neo FLOW

UPGRADE

November, 2022

Upgrade Neo Inlet

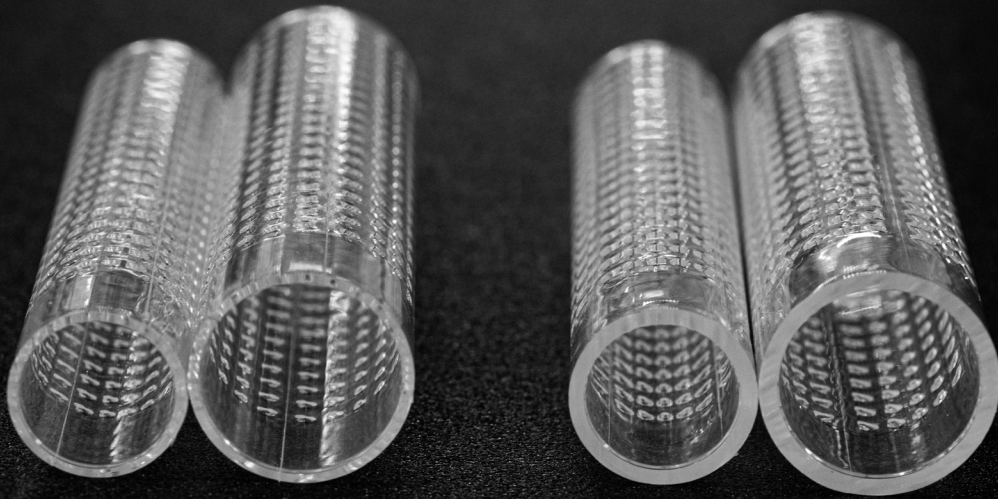
The thickness of the Neo Inlet is increased from 1mm to about 1.5mm, significantly reducing the possibility of breakage. The material is the same.
